Relocation of SR 113 From CR 31 To Richland  
Creek @ Old Alabama Road Relocation – Phase II  
P.I. Nos. 621440 and 621445  
STP00-0179-01(010) and BHF00-0179-01(011)

Value Engineering Study Report

July 2010

AMERICAN ENGINEERS, INC.

1:10 HOR STATE OF GEORGIA EASTWORK CROSS SECTIONS SR 113, STA. 209+50 DRAWN

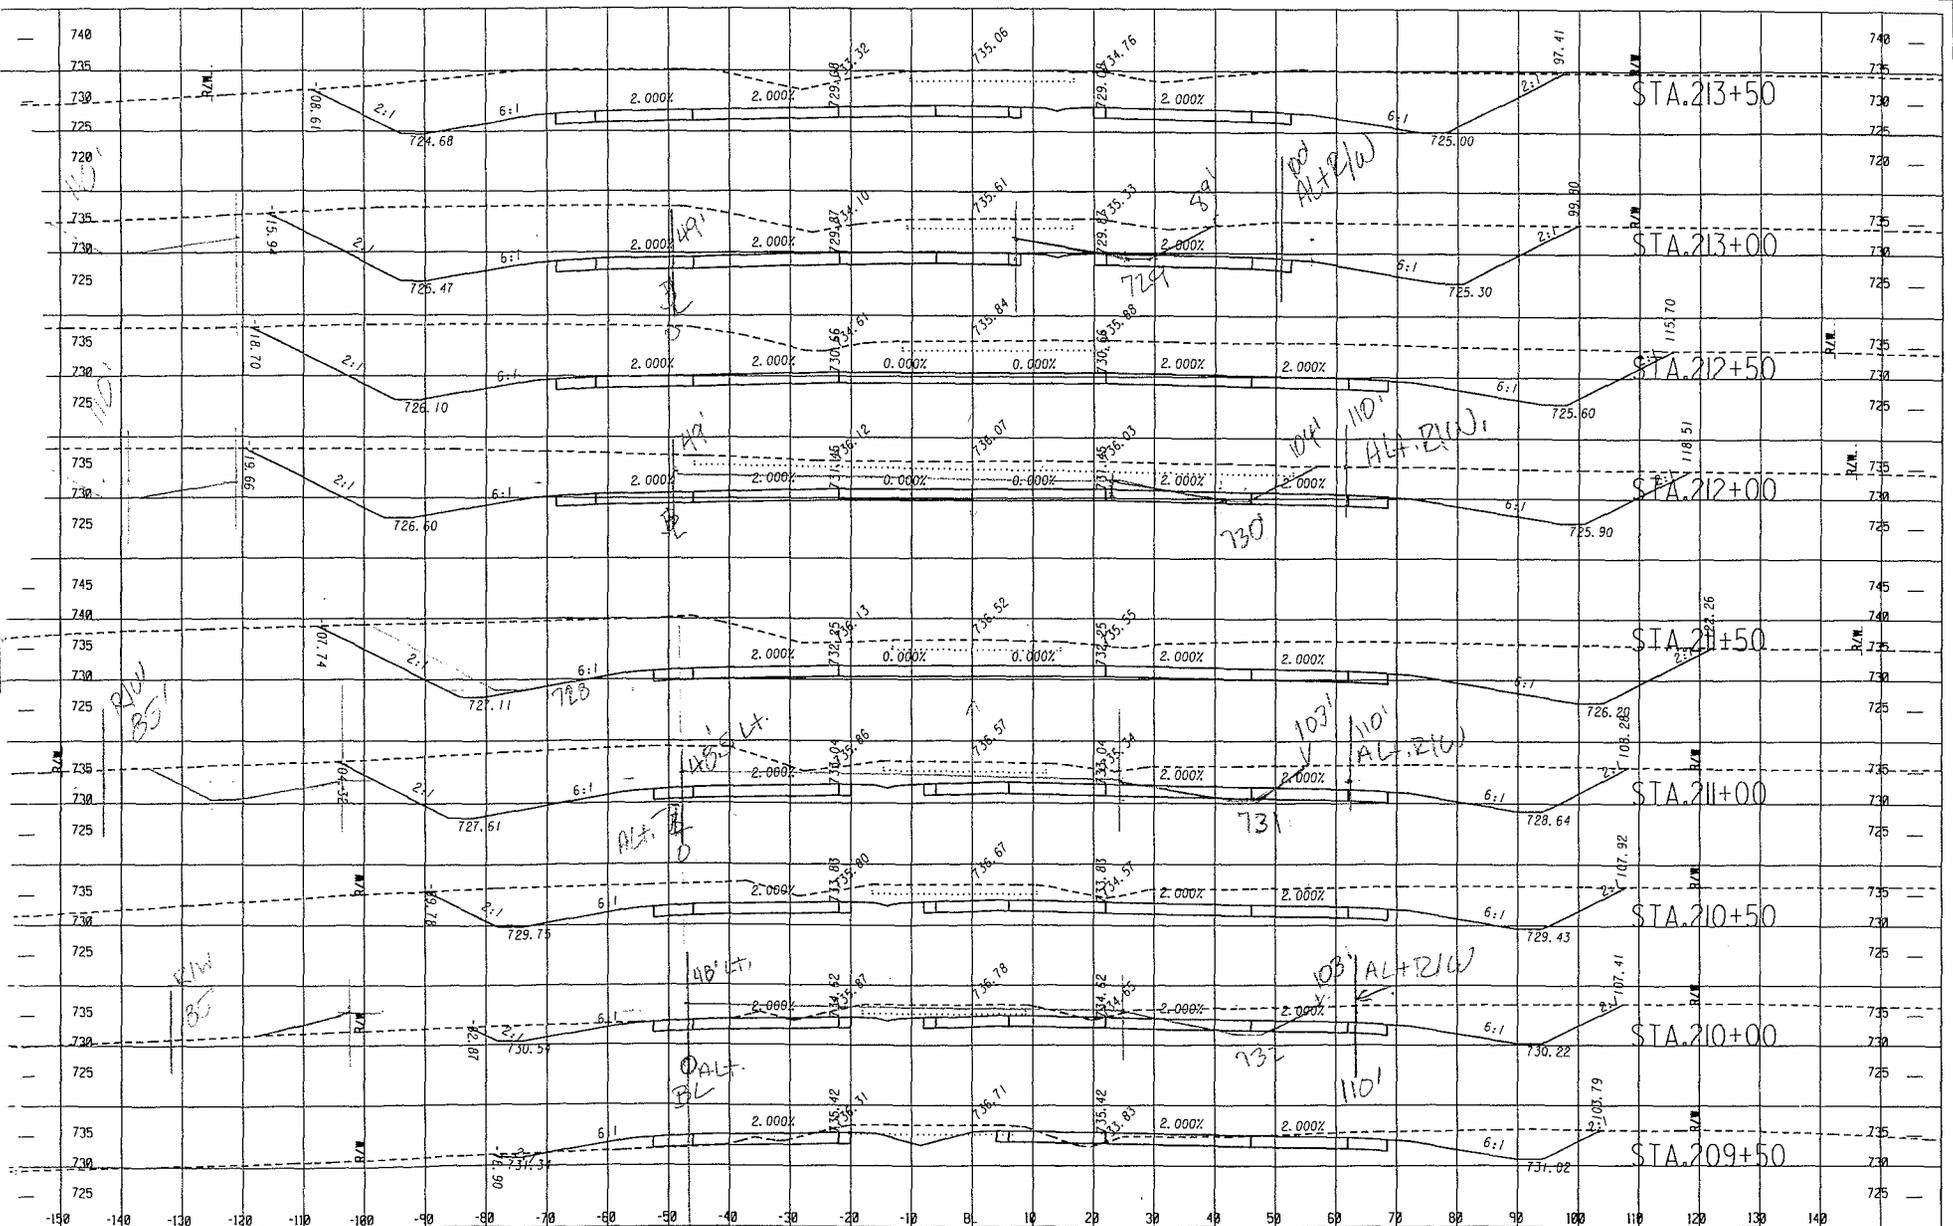
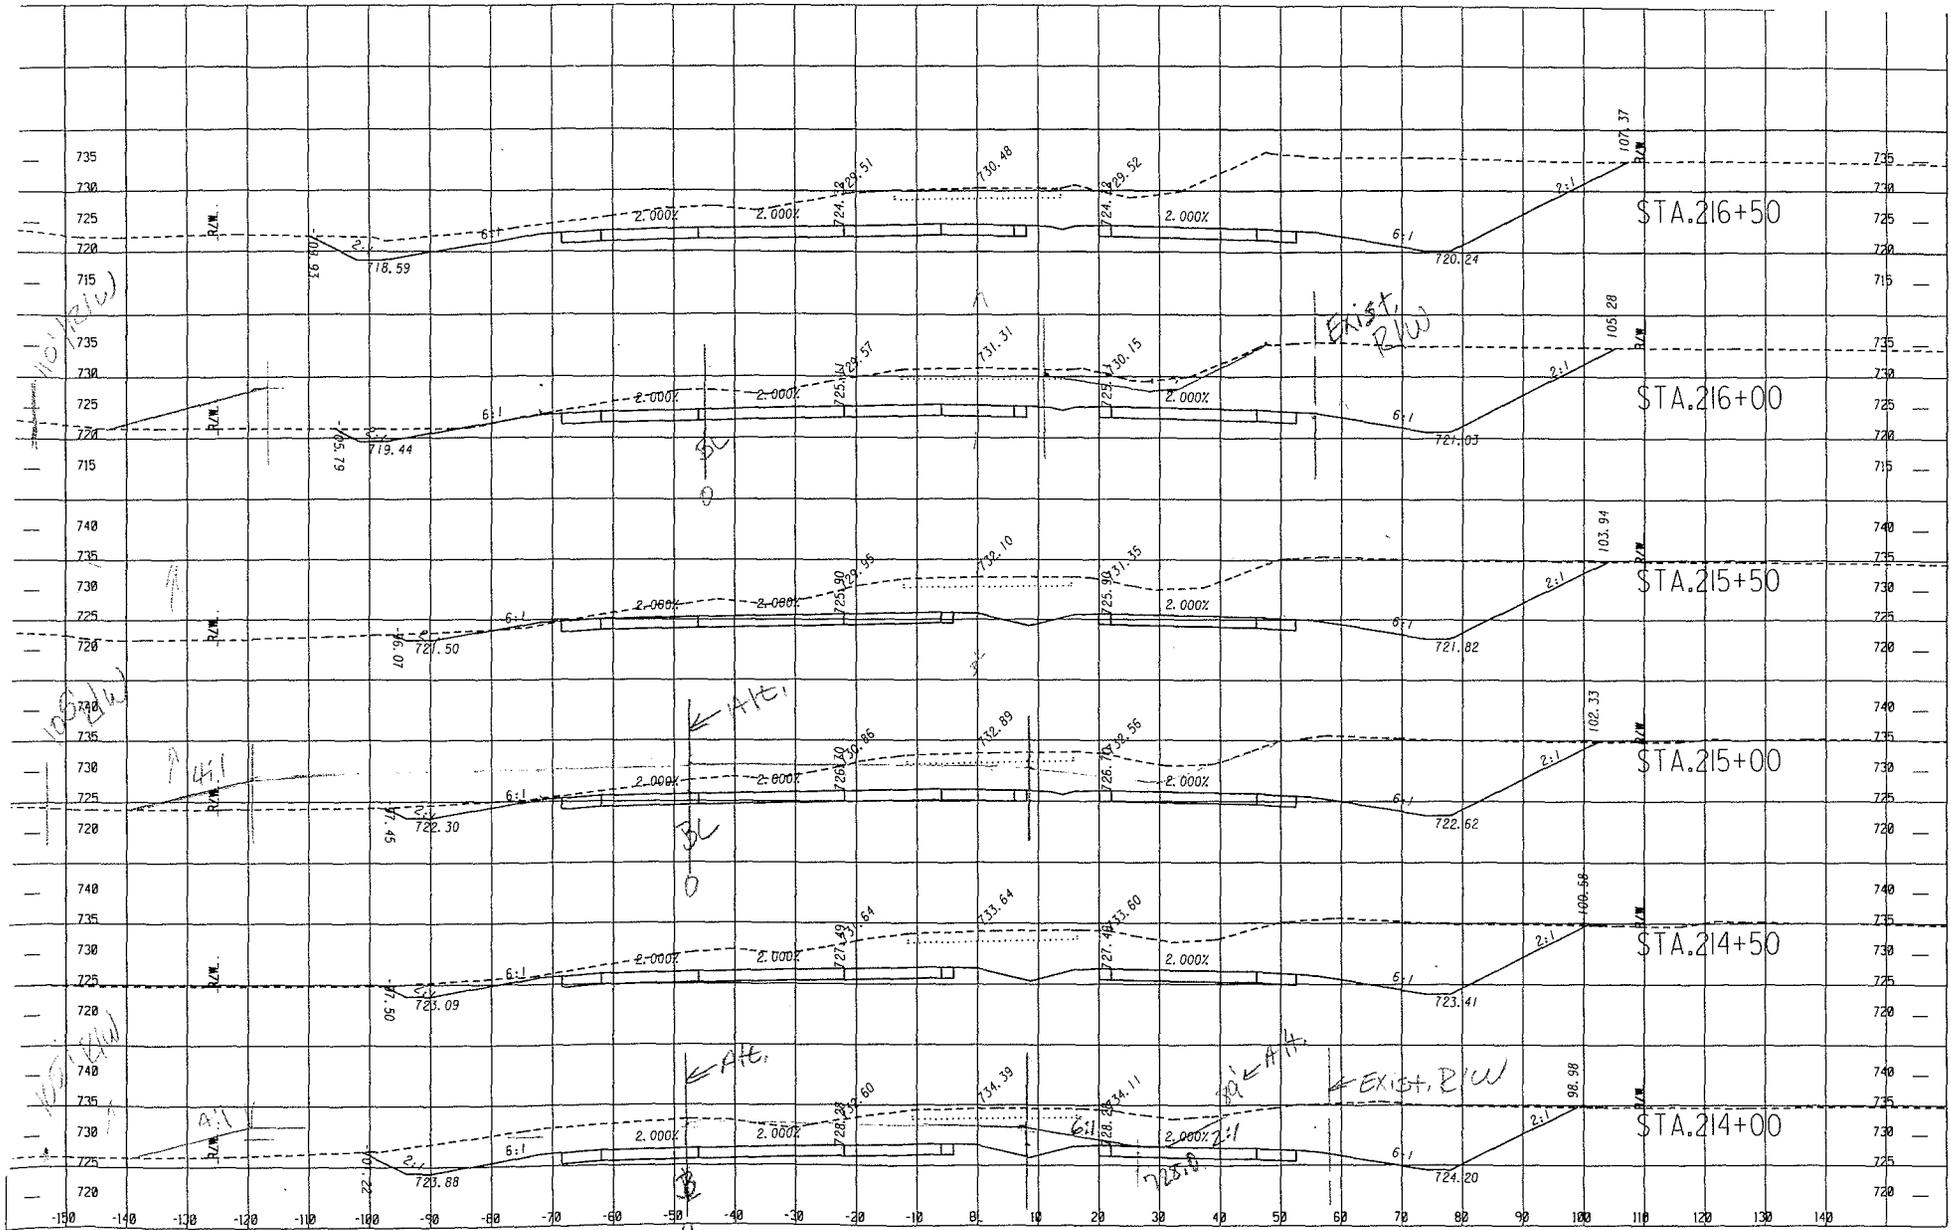
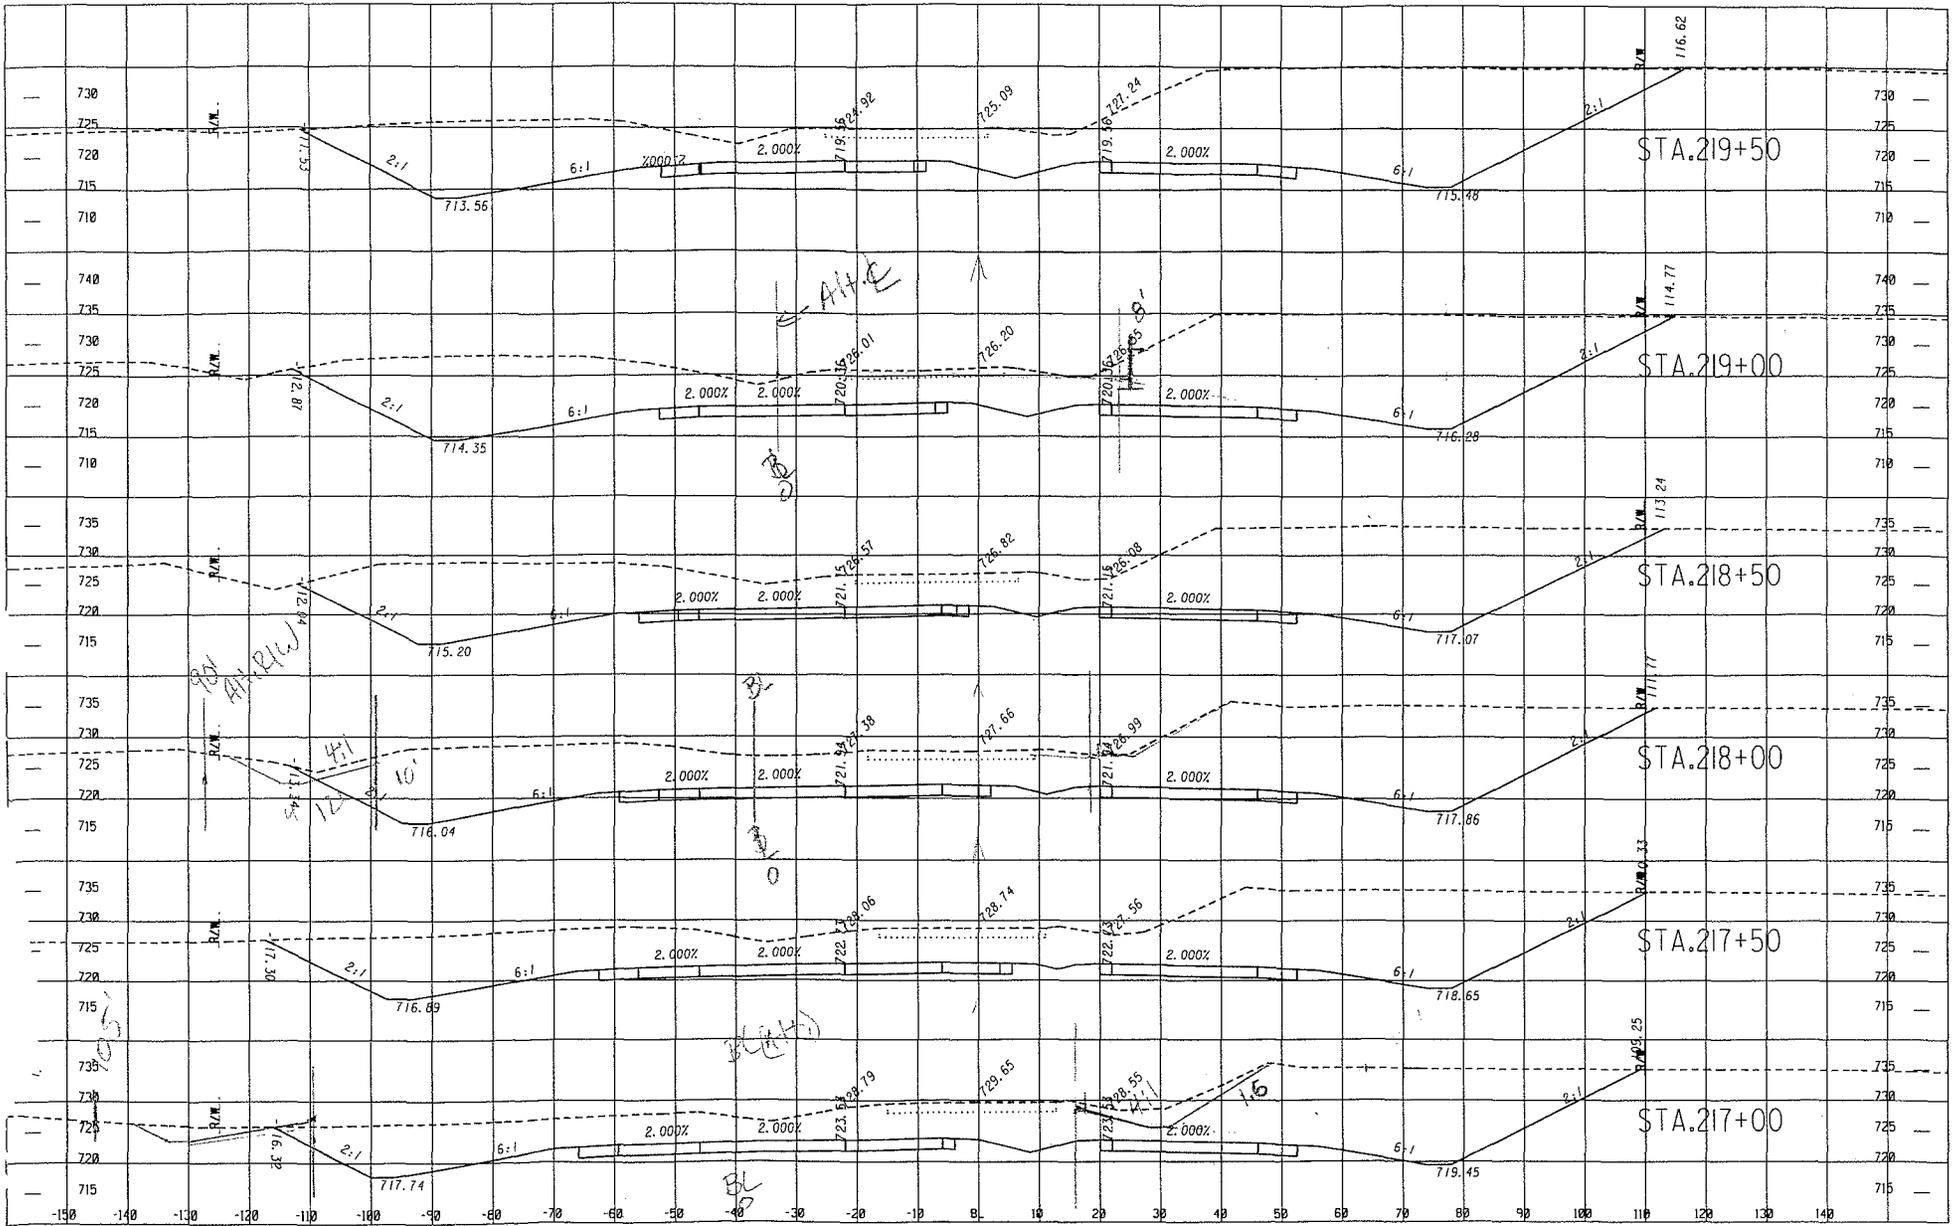
- Reduces right of way impacts
- Reduces right of way requirements
- Reduces unclassified excavation requirements

- Increases retaining wall, guardrail, and drainage construction requirements

**DESCRIPTION:** REPLACE THE 8 FT. X 6 FT. CONCRETE BOX CULVERT WITH 72-IN.-DIAMETER REINFORCED CONCRETE PIPE

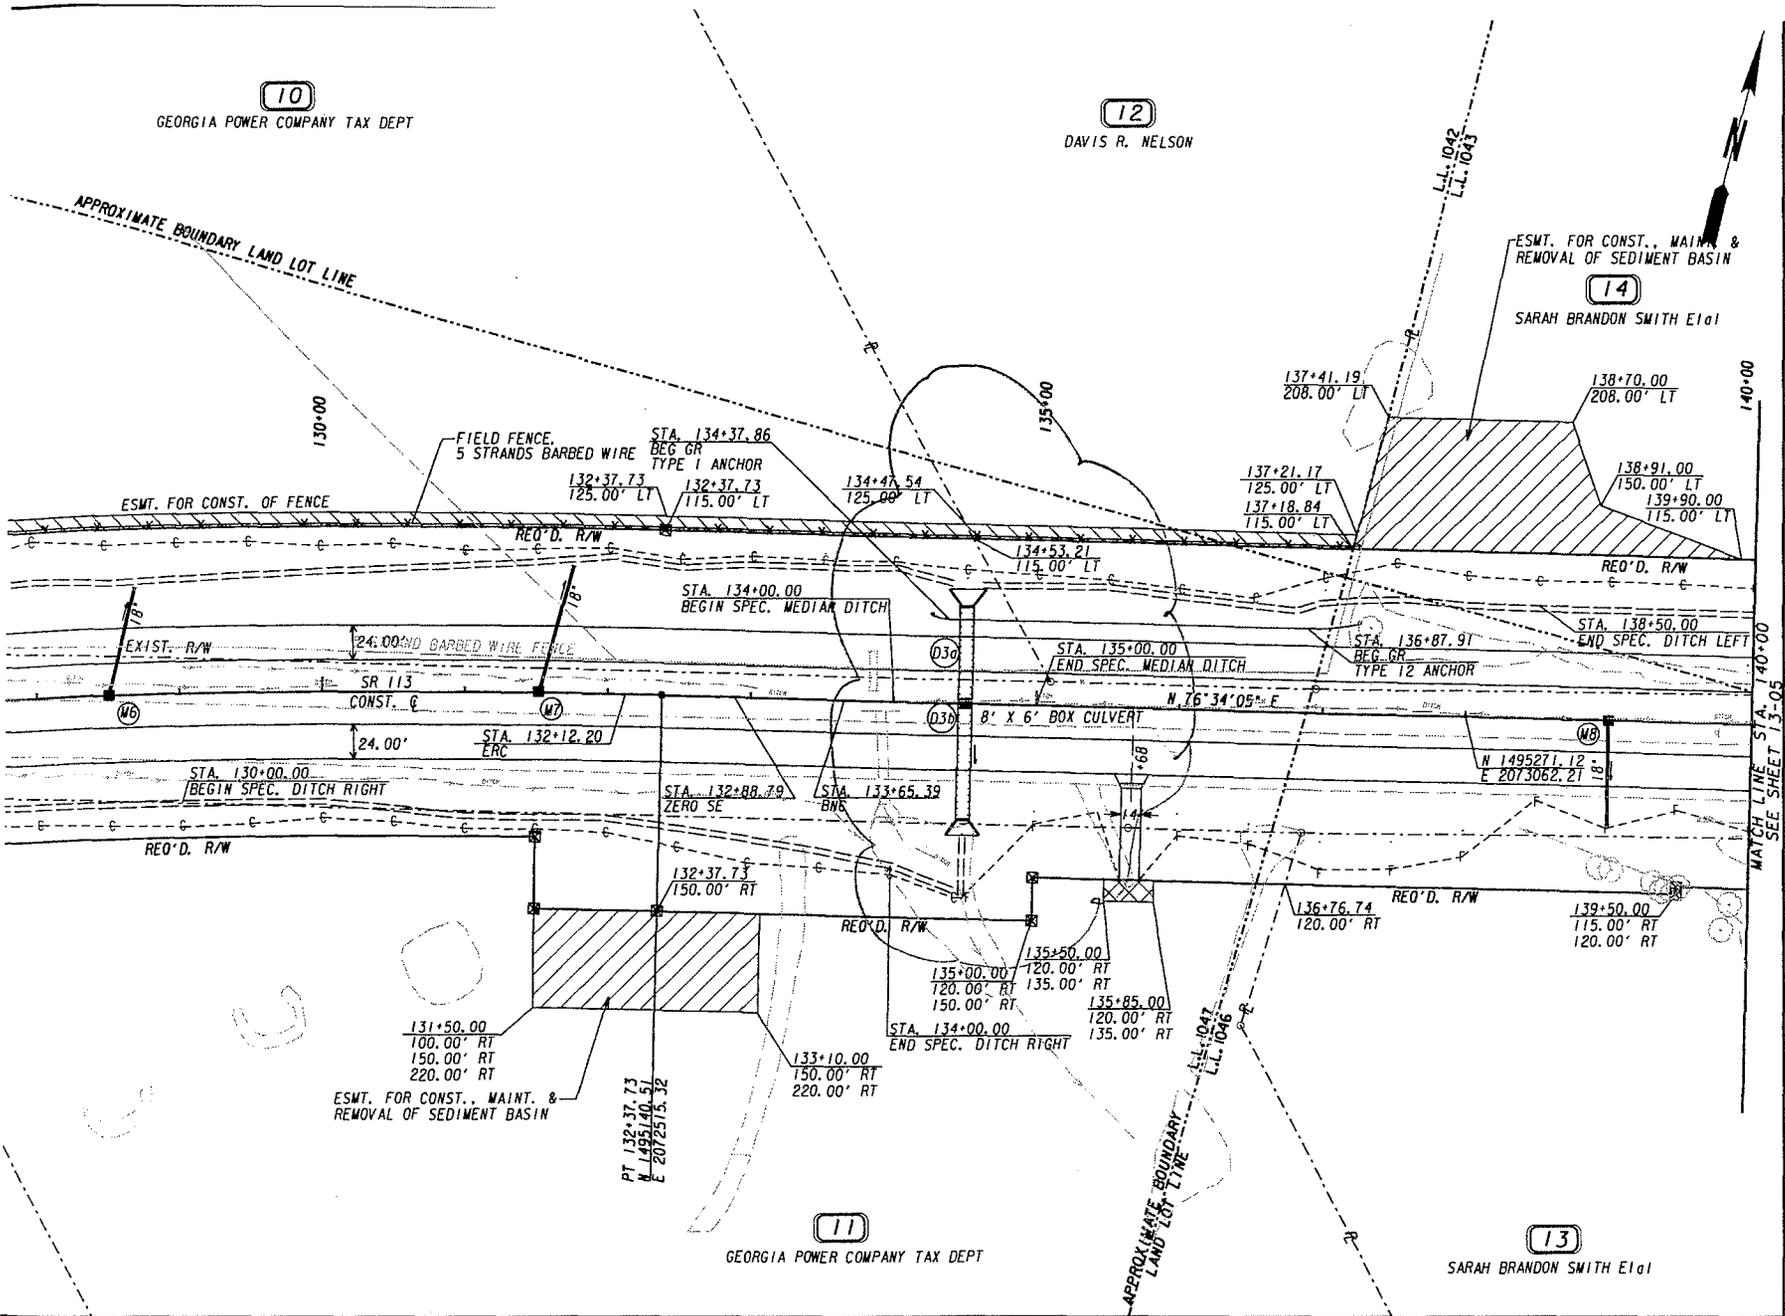
Replace the concrete box culvert with dual 72-in.-diameter reinforced concrete pipes.

PROJECT: **WIDENING AND RECONSTRUCTION OF SR 113 FROM CR 23/LUCAS ROAD TO RICHLAND CREEK**  
 P.I. No. 621760  
 Bartow County, GA

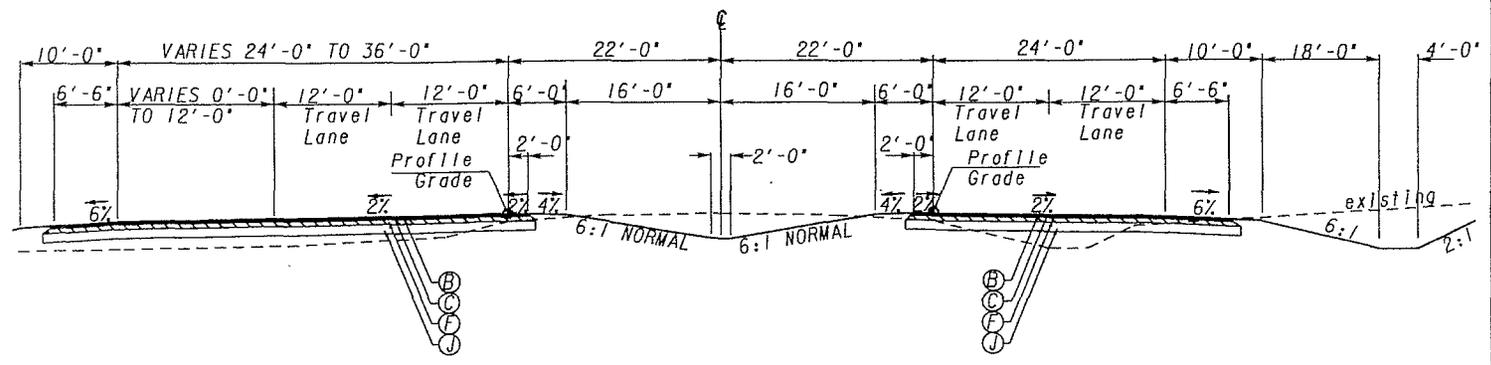
AS DESIGNED  ALTERNATIVE
